***MODIFICATION REQUEST:  
NorthConnex Modification 2***

***Modification to Condition B2 -  
Ventilation Outlet Heights  
SSI 6136 (MOD 2)***

Environmental Assessment Report  
Section 115ZI of the *Environmental  
Planning and Assessment Act 1979*

February 2018

**Figure 2.** Updated visual catchment mapping of the proposed tip height increased of the northern ventilation outlet (Source: Proponent's Modification Request)

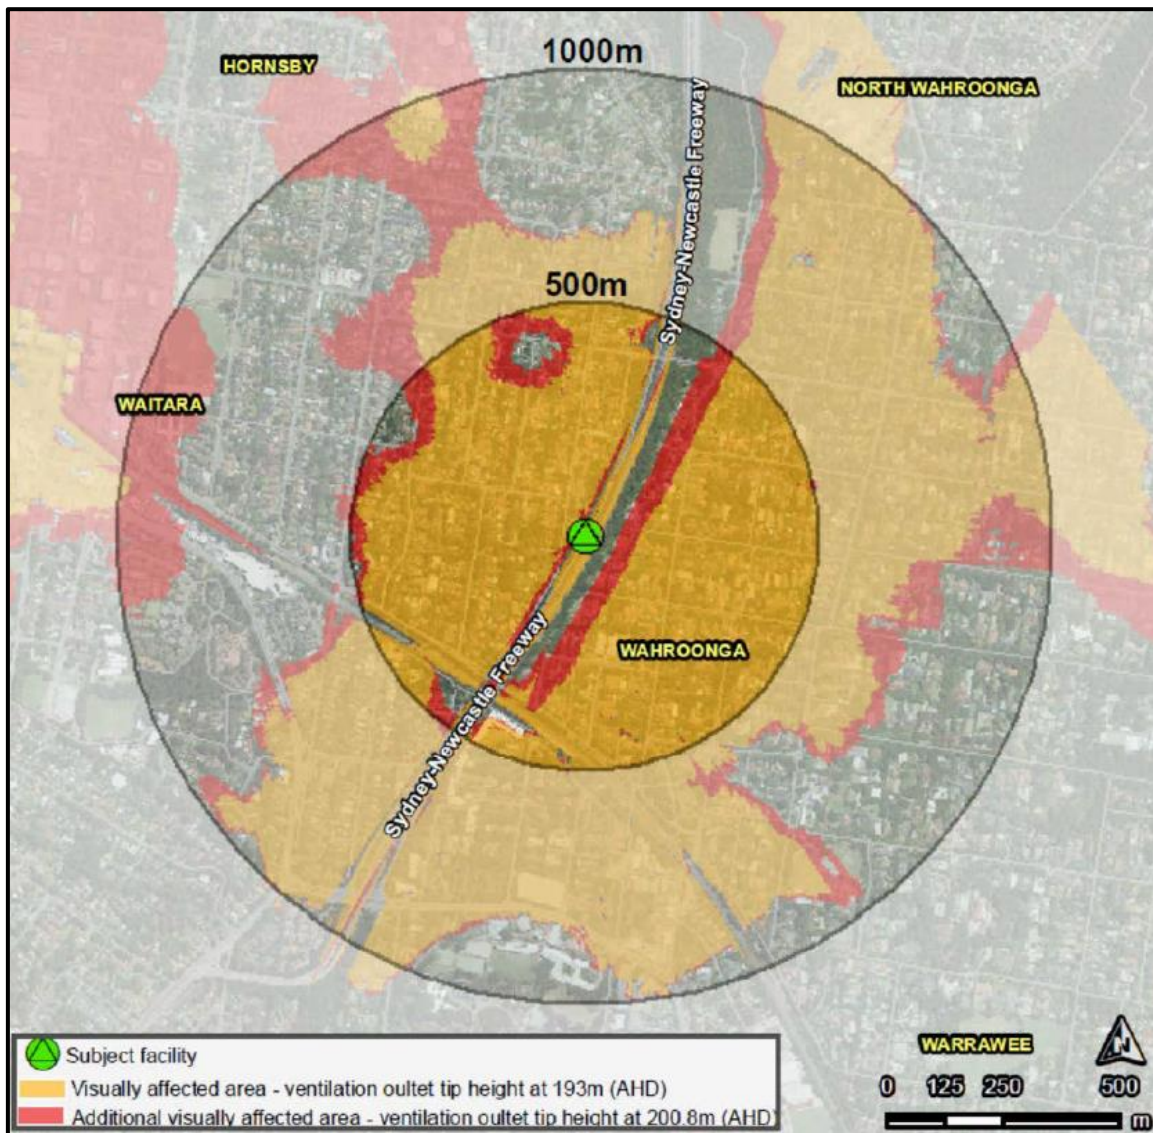
The proposed increased height of the northern ventilation outlet means it could potentially be seen by a greater number of receivers in the visual catchment compared with that assessed in the EIS or PIR.

Consistent with the EIS, the Proponent has assessed the visual impacts of an increased outlet height for a visual catchment of up to one kilometre surrounding the northern ventilation outlet. **Figure 2** indicates the areas where additional receivers may be able to see the higher ventilation outlet.

The Department acknowledges that increasing the height of the northern ventilation outlet by 6.8 metres above that approved for the original project would make it visible from more vantage points. However, it is also acknowledged that the catchment presented in **Figure 2** is based on topography alone and does not take into account potential obstructions such as vegetation or buildings. As such, the Department considers this approach to be conservative.

Whilst a greater number of receivers may be able to view a higher outlet, this impact is likely to diminish or be obscured with increased distance. Additionally, it is likely that any views beyond those receivers immediately adjacent to the site of the outlets will be partial. The Department considers that the urban design treatments to be applied to the ventilation facilities will assist in mitigating visual impacts.
